Project	IEEE 802.16 Broadband Wireless Access Working Group < http://ieee802.org/16 >	
Title	Access Messages for Direct Signaling in the AAS Relay Zone.	
Date Submitted	2008-03-14	
Source(s)	Dale Branlund, Matt Volpe, Will Sun BRN Phoenix Inc. 2500 Augustine Drive Santa Clara, CA, USA 95054	Voice: +1-408-572-9703 Fax: +1-408-351-4911 dbranlund@brnphoenix.com
	John Norin, Robert Popoli The DIRECTV Group, Inc. 2250 East Imperial Hwy El Segundo, CA 90245	Voice: +1-310-964-0717 Fax: +1-310-535-5422 john.norin@directv.com
Re:	Working Group Letter Ballot Recirc #28b, Technical Comments and Contributions regarding IEEE Project P802.16j; Draft Amendment P802.16j/D3.	
Abstract	This contribution describes the Direct Signaling messages transmitted in the access channel of the AAS Relay Zone to accomplish ranging and bandwidth request and grant.	
Purpose	This document provides the necessary access messaging to properly accomplish ranging and bandwidth request/grant within the AAS Relay Zone for Direct Signaling mode of operation.

Access Messages for Direct Signaling in the AAS Relay Zone

Figure 2. Transmitter Signal Processing

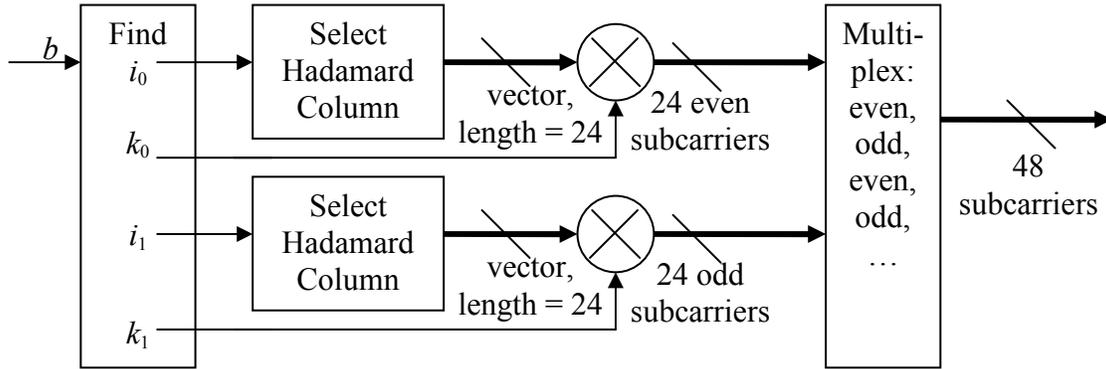
The signal processing for the transmitter is shown in Figure 1. b represents the DLI codeword and ranges from 0 to 2303. It is then broken down into two groups of 24. i_0 selects one of 24 Hadamard columns for the first group and ranges from 0 to 23. k_0 selects the BPSK modulation for the first group. i_1 selects one of 24 Hadamard columns for the second group. k_1 selects the BPSK modulation for the second group. The Hadamard matrix is based on the Matlab function: $\mathbf{H} = \text{hadamard}(24)$. The first group of 24 sub-carriers is multiplexed with the second group of 24 sub-carriers. If the indices to the sub-carriers of a slot were numbered from 0 to 47, the even numbered sub-carriers come from the first group of 24 and the odd number sub-carriers come from the second group of 24. The first sub-carrier of the slot is $H(0, i_0) k_0$, the second, is $H(0, i_1) k_1$, the third is $H(1, i_0) k_0$, the fourth is $H(1, i_1) k_1$, etc., where zero-based indexing is assumed when accessing the Hadamard matrix, $H(n, i)$.

Insert Figure xxxa (.16e)/Figure xxxa (Rev2) as indicated:
